Addendum #1
Jungle of the Apes Workspace Remodel RFP 2024
Project Number: 2024-01-042

PRE-BID MEETING NOTES | OCTOBER 31, 2024 | 9:00 AM CST

Image 1

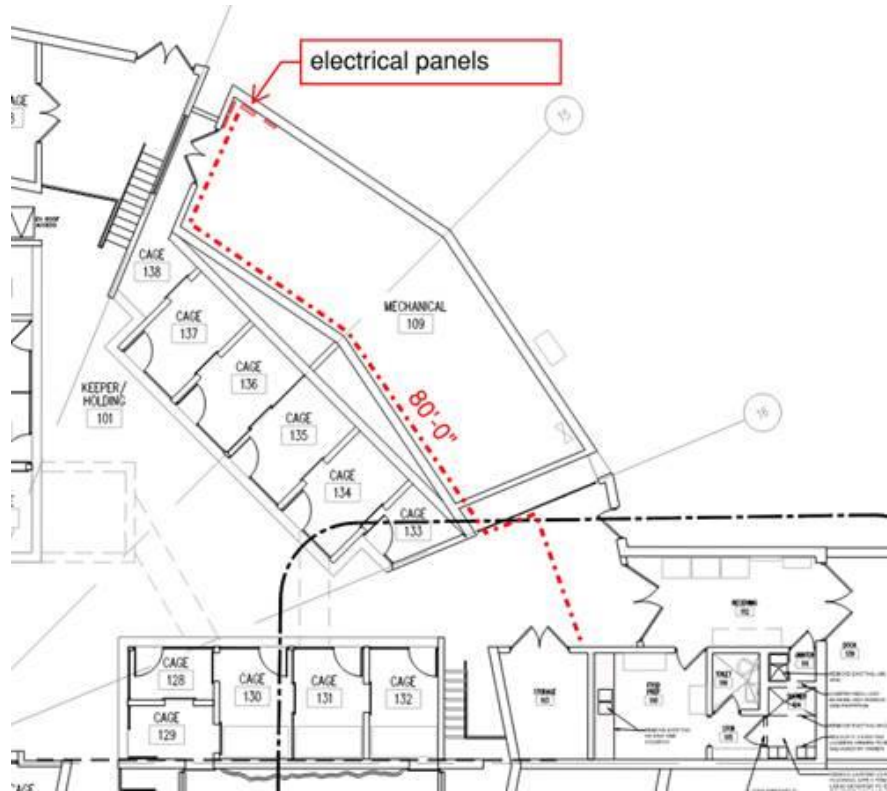
4. Are the documents provided sufficient to secure building permits? **The costs of any permits, if required, will be reimbursed by the Zoo.**
5. How far might electrical services need to be run? **All of the rooms do currently have electrical service to outlets and lighting that sufficiently serve similar conditions. The distance to the main electrical panel, in the mechanical room shown on the lower level building plan, is about 80 ft. (see image #1 below).**

Image 2

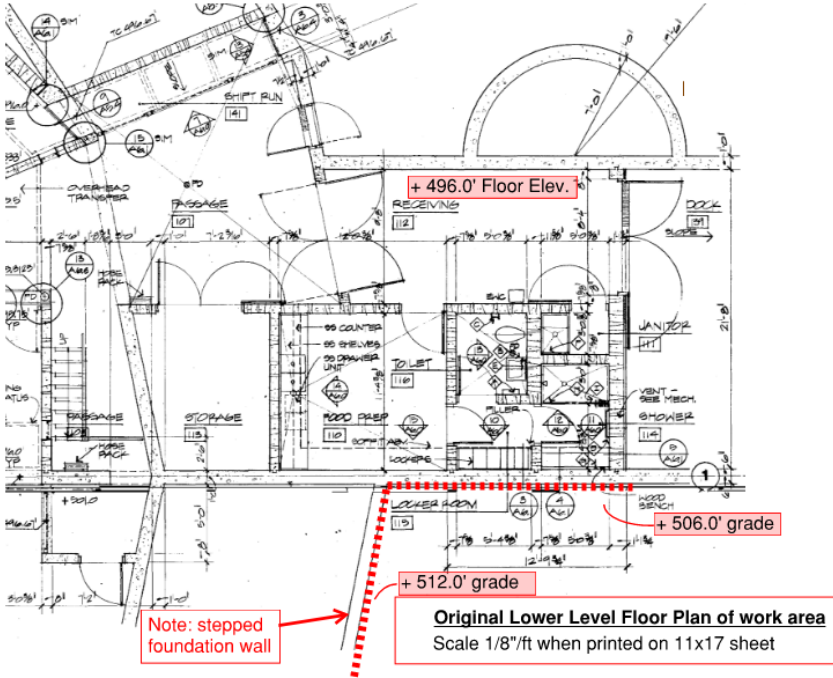
7. What is the depth of the foundation wall at the area for excavation and waterproofing? **The foundation wall steps in this area. The depth of the waterproofing needed will vary between 10' and 16' maximum (see images #2 and #3 below).**

2. At the area to be excavated for Alternate #2, what is the depth of the footing in this area? Is there an estimate for the Sq. footage of waterproofing required at this area? **The depth of the waterproofing needed on the foundation wall will vary between 10' and 16'.** See supplemental drawings below. There appears to be a water line as well as power and communications lines adjacent to, but not through, the noted area of excavation. The Zoo will locate and mark these private utilities for you.

Image 4 utility map

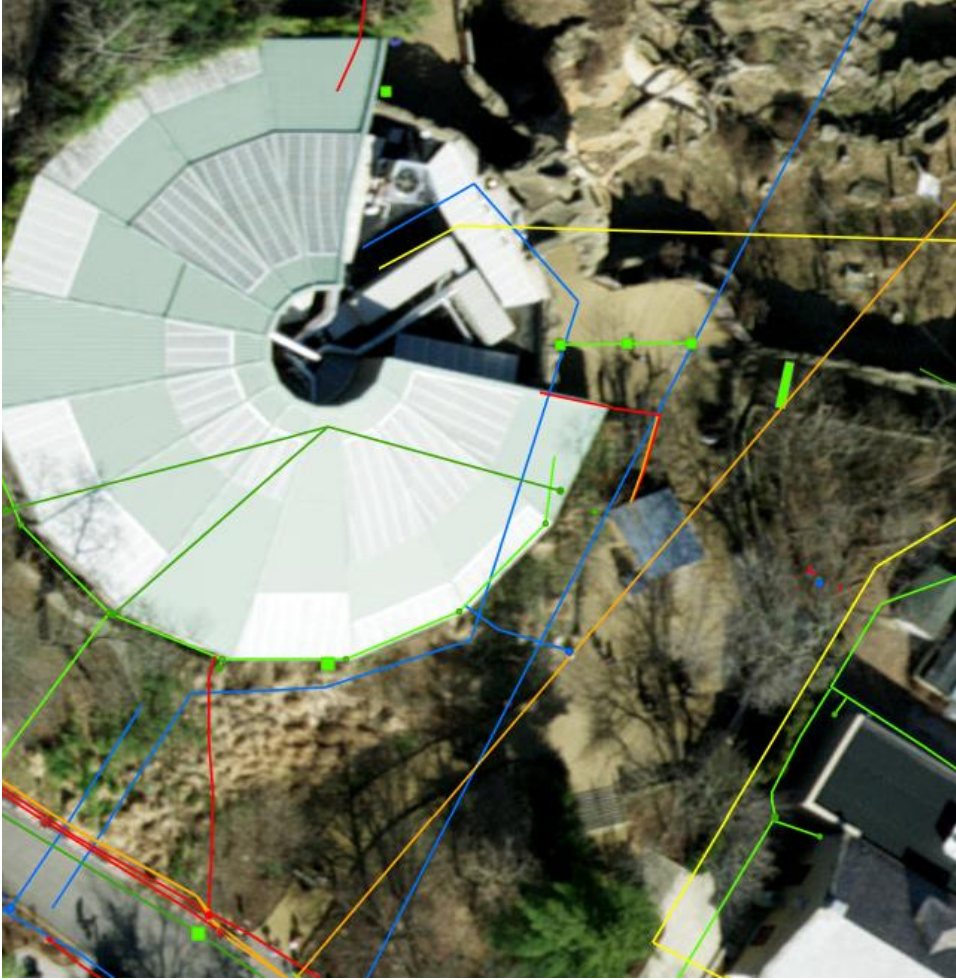
8. Are there any known existing utilities in the area? **There appears to be a water line plus power and communications lines adjacent to, but not through, the noted area of excavation. The Zoo will locate and mark these private utilities.**
